Noyac Bay

#307
ORIGINAL
LAYOUT
INVENTORY
SUITE

NOYAC BAY: 307

Suite #307

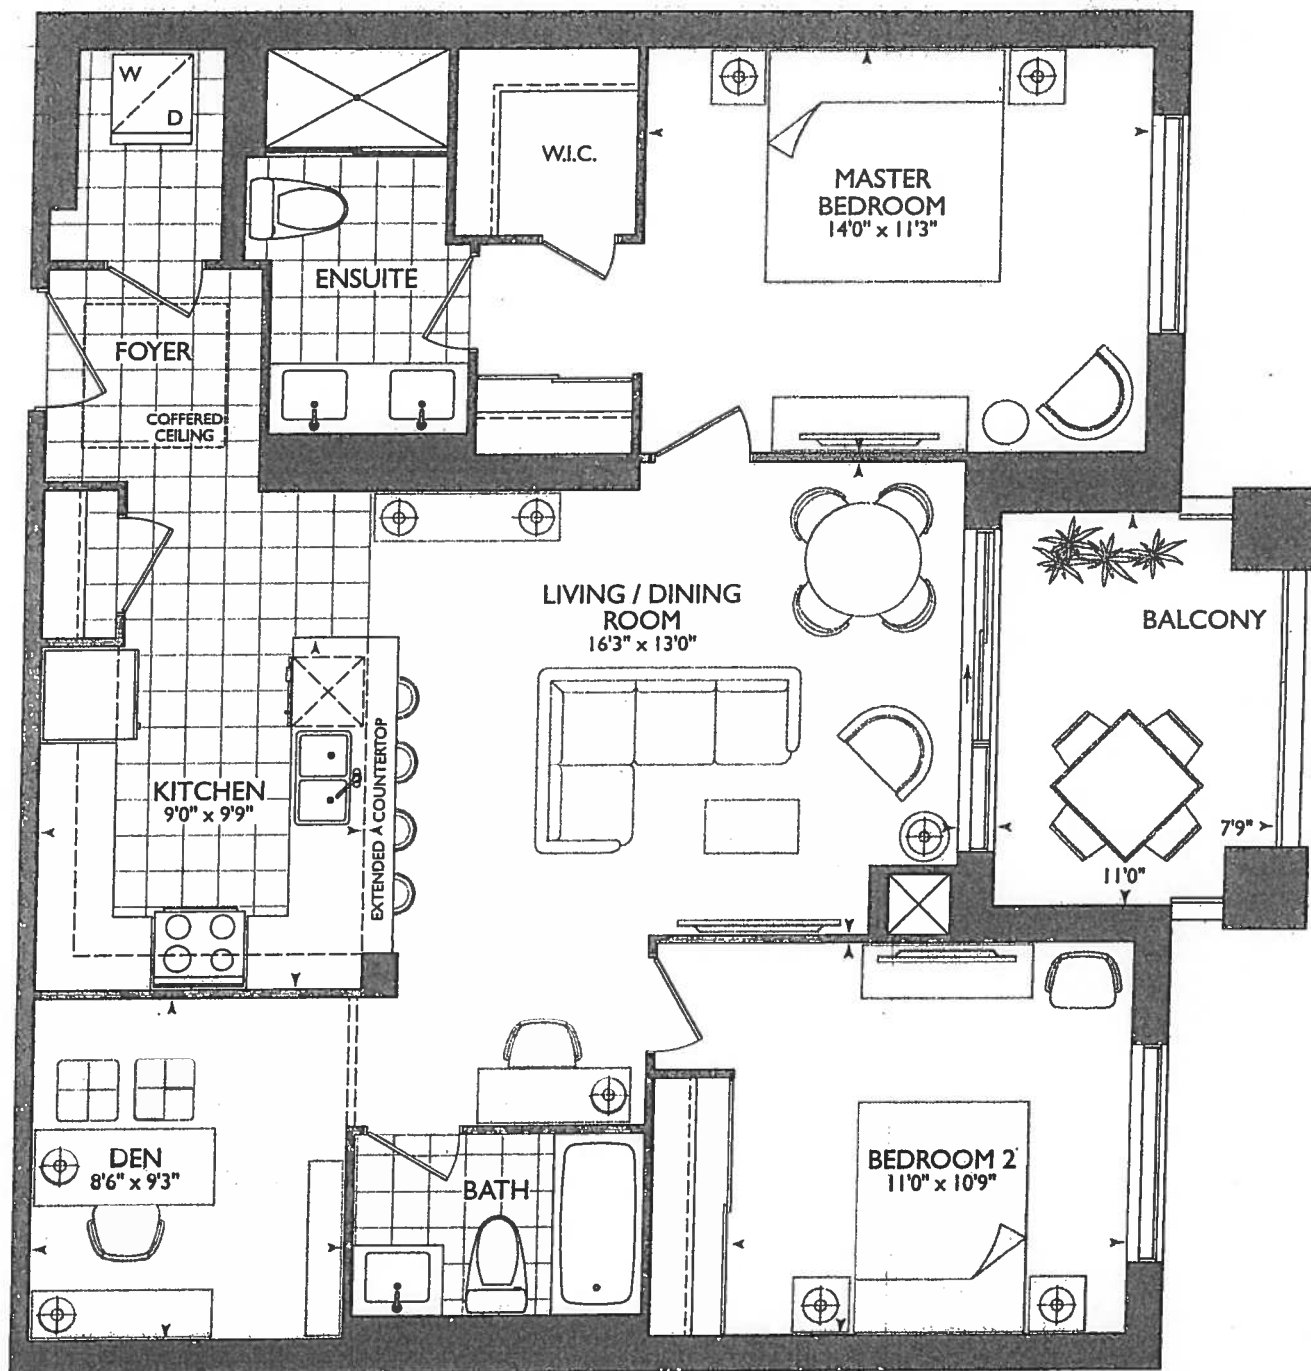
- ENSUITE WALL REVISED AS PER ARCHITECTURE DRAWINGS
- LAUNDRY DOOR SWING TO OPEN AGAINST THE ENSUITE WALL

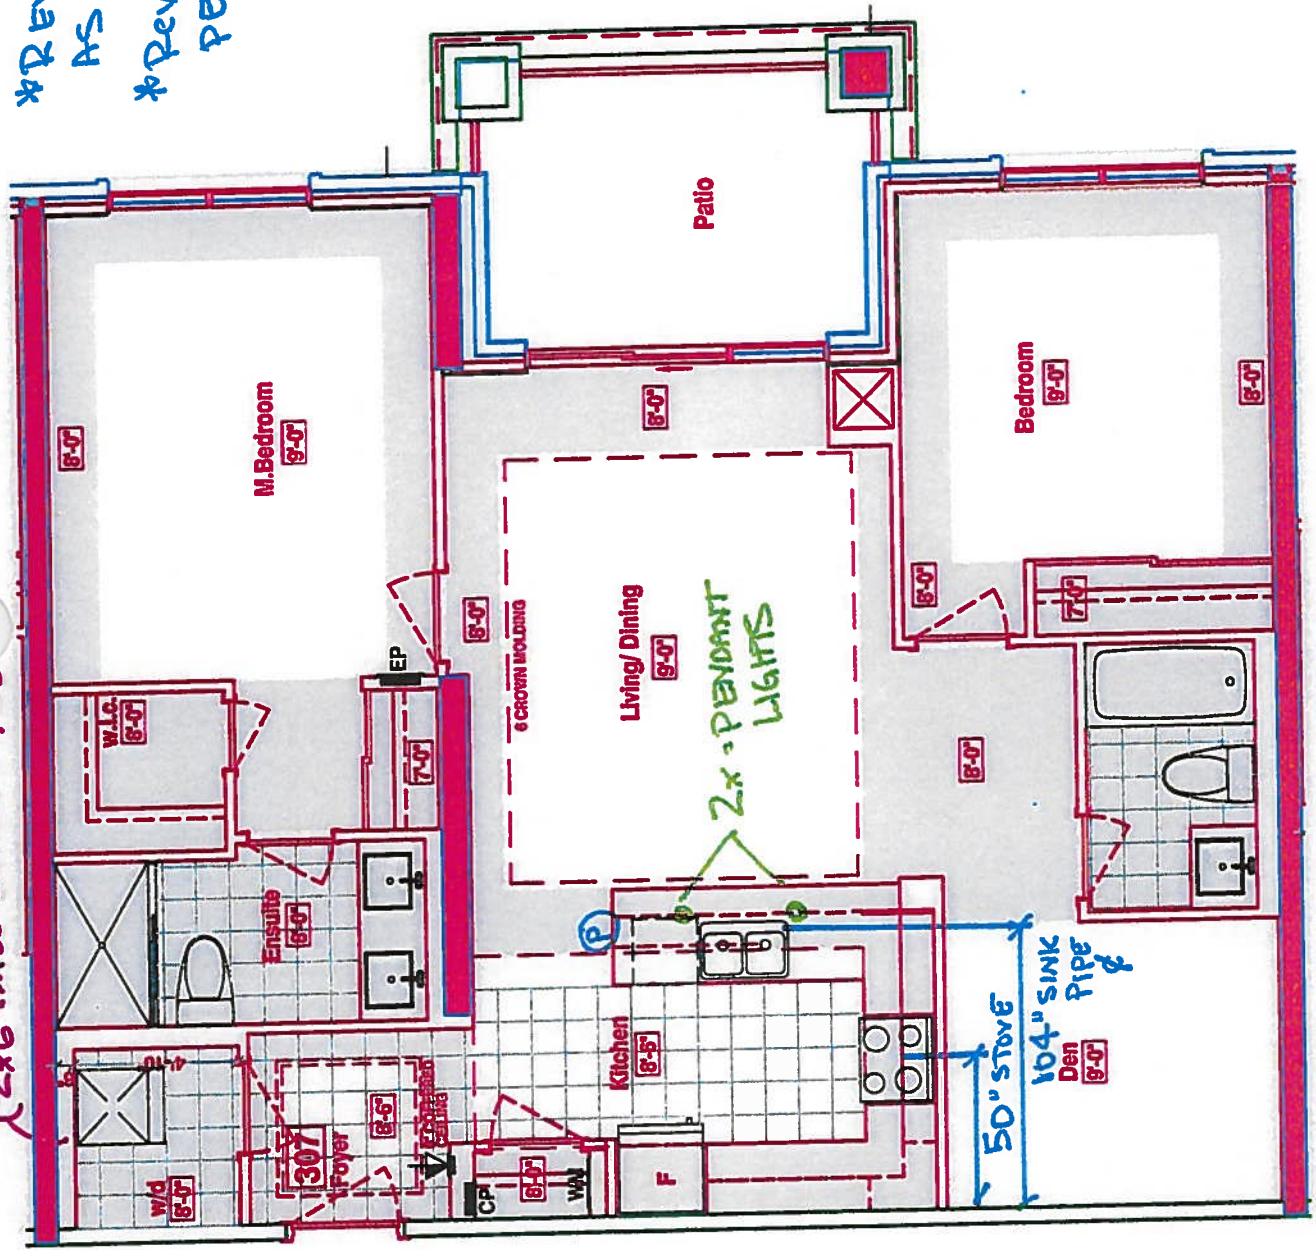
- #307 - INVENTORY SUITE
- *REVISED LAUNDRY DOOR SWING, AS PER THIS BROCHURE
- *REVISED ENSUITE WALL AS PER THIS BROCHURE.

6" WALL BEHIND W/D

ELIMINATE JOG AT FRIDGE WALL
